Project No. 2628-066  
R.L. Harris Hydroelectric Project  
Response to License Application Additional Information Requests

### Response to Harris Project License Application Additional Information Requests

## **12-23-2021 FERC ADDITIONAL INFORMATION REQUEST #1**

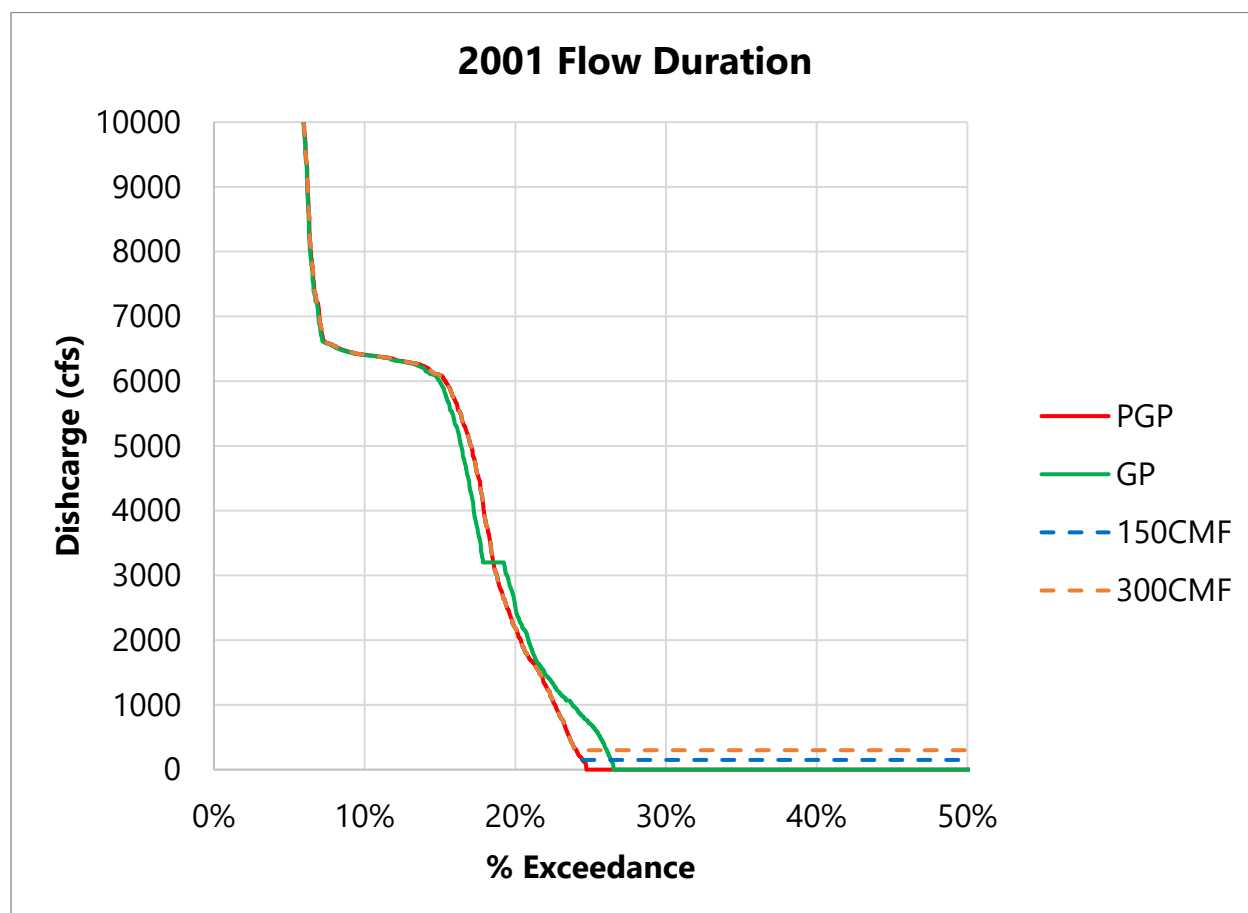
4. *Commission staff's Comment No. 16 on the Preliminary Licensing Proposal (PLP) requested elaboration on how the 150-cfs continuous minimum flow scenario was created by amending the "Pre-Green Plan" scenario such that no hourly interval had less than a 150 cfs discharge from Harris Dam. The response on page 21 of the license application indicates that the HEC-RAS upstream hydrograph was revised to increase the inflows less than 150 cfs to 150 cfs. This is acceptable if there are relatively few "Pre-Green Plan" hydrograph ordinates less than 150 cfs. So that Commission staff can evaluate this scenario, please compare the total acre-feet in the upstream HEC-RAS inflow hydrographs for the Green Plan (baseline), "150 Continuous Minimum Flow" and "300 Continuous Minimum Flow" alternatives. If the difference in acre-feet is significant (i.e., more than 4 percent), please revise the HEC-ResSim release rules accordingly, and re-run the "150 Continuous Minimum Flow" and "300 Continuous Minimum Flow" HEC-RAS models, as this difference in the total volume of inflow could affect the results for the recreation (i.e., boatable days), drought operations, and downstream temperature fluctuation simulations.*

As discussed in the technical meeting with FERC on January 20, 2022<sup>1</sup>, the 2001 discharge hydrograph for Harris Dam represents the upstream boundary for the HEC-RAS model simulations. Therefore, the input boundary condition for HEC-RAS is not from the HEC-ResSim model output. The 2001 historical discharge hydrograph was used as a basis for all downstream evaluations for the Downstream Release Alternatives. The 2001 discharge hydrograph consists of actual project operations prior to implementation of the Green Plan in 2005, not HEC-ResSim model results. For the 150 cfs and 300 cfs continuous minimum flow alternatives, every hourly ordinate of the 2001 discharge hydrograph was adjusted such that the flow did not decrease below the minimum being evaluated.

Both the 150 cfs and 300 cfs alternatives release a greater volume of water from Harris Dam than the Green Plan alternative. However, this was a known assumption when the plans were selected and run, with Alabama Power understanding that these plans would require greater discharges of volume from the Harris Dam. In other words, releases were not adjusted in the hydrograph other than for the minimum flow and Alabama Power did not adjust the volume for a nearby hour to make the adjustments to the hydrograph.

# Pollinator Plots at Little Fox Creek

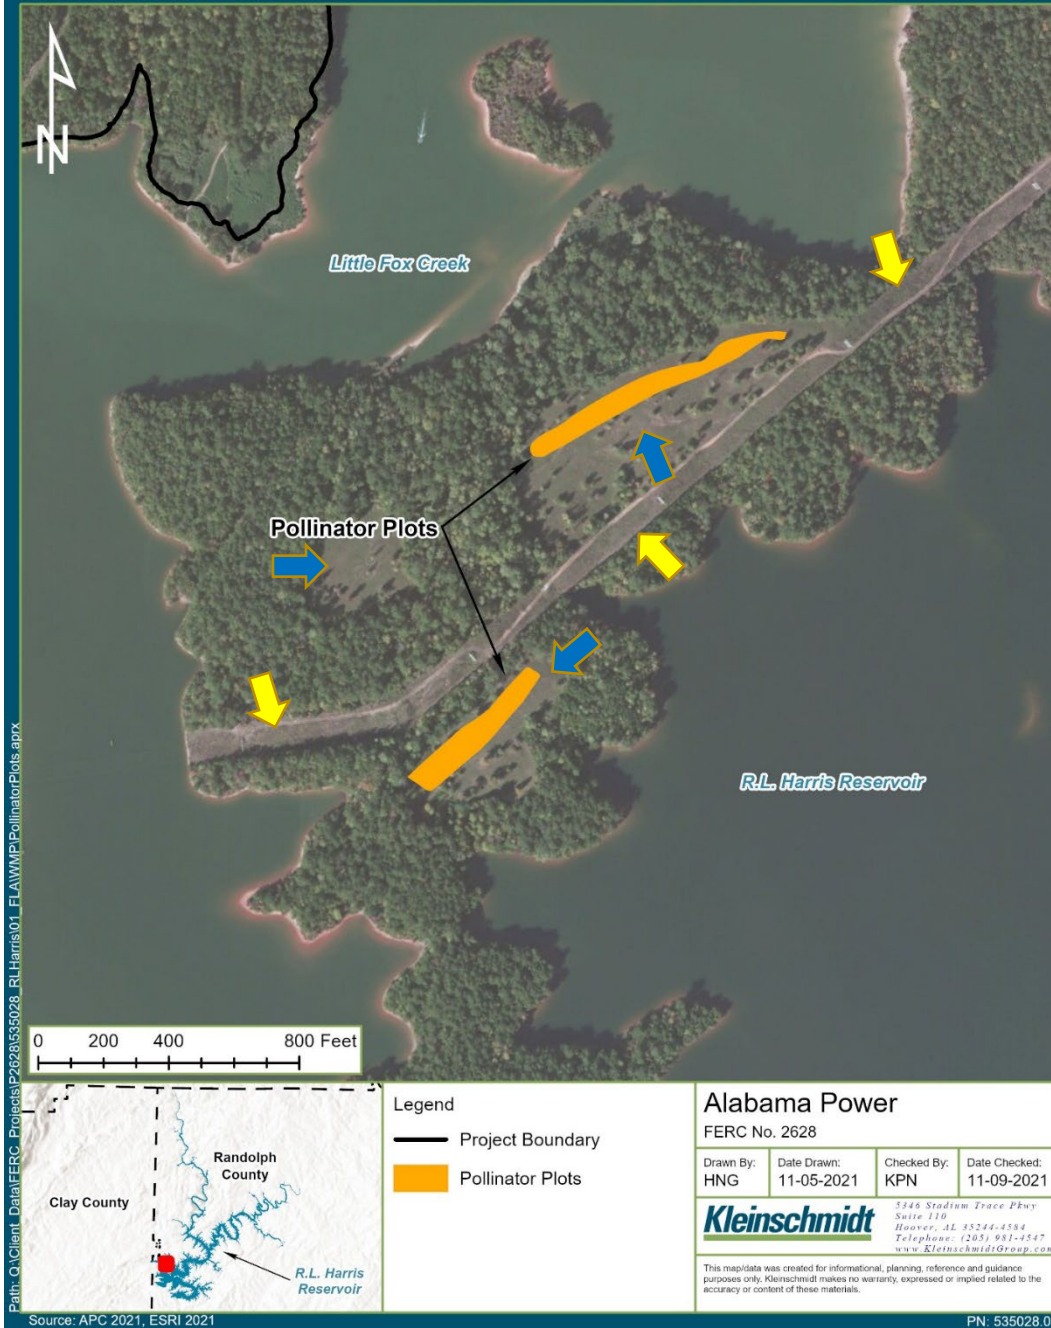
14. Section 10.1.4, Lake Harris Wildlife Resources, states that “Alabama Power maintains Pollinator Plots at Little Fox Creek that strengthens natural habitat for the Monarch Butterfly and other pollinators such as bees, moths, and beetles. Little Fox Creek was developed with plants chosen for that specific habitat in order to benefit pollinator species.” Please provide a list of representative plant species occurring in the pollinator plots, including specific milkweed species and any nectar-rich species known to benefit monarchs. Also, please provide a map showing the location of the pollinator plots at Little Fox Creek in relation to the project boundary, primary project features, and locations where Alabama Power manages herbaceous vegetation. In addition, please provide a detailed description of any vegetation management (i.e., manual, mechanical, chemical, and/or biological) that occurs within, and adjacent to the pollinator plots. If herbicides are used to control vegetation near the pollinator plots, please include the method of application (e.g., foliar, stump, stem, and/or vine). Finally, please describe whether monarch butterflies have been observed at the pollinator plots or other locations in the project boundary.

Figure 8-1 of the proposed Wildlife Management Plan (provided below) illustrates the location of the pollinator plots at Little Fox Creek in relation to the project boundary, which is shown in top left corner of the map. No primary project features are located nearby.

Adjacent to the plots, Alabama Power manages three permanent openings (identified below in Figure 8-1 using blue arrows), by mechanical means (i.e., annual mowing) in accordance with Section 6.1.1 of the Wildlife Management Plan, which was submitted as part of the FLA. Additionally, Alabama Power uses integrated vegetation management (IVM) at the adjacent transmission line right-of-way (identified in Figure 8-1 below with yellow arrows) as discussed in Section 10.1.5.1 of Exhibit E of the FLA.

Alabama Power staff has observed adult Monarch Butterflies at the plots but no eggs, larvae, or pupa. However, no specific efforts for observation or survey have been conducted. Additionally, Alabama Power staff have observed adult Monarch Butterflies at the nearby Flat Rock Park.
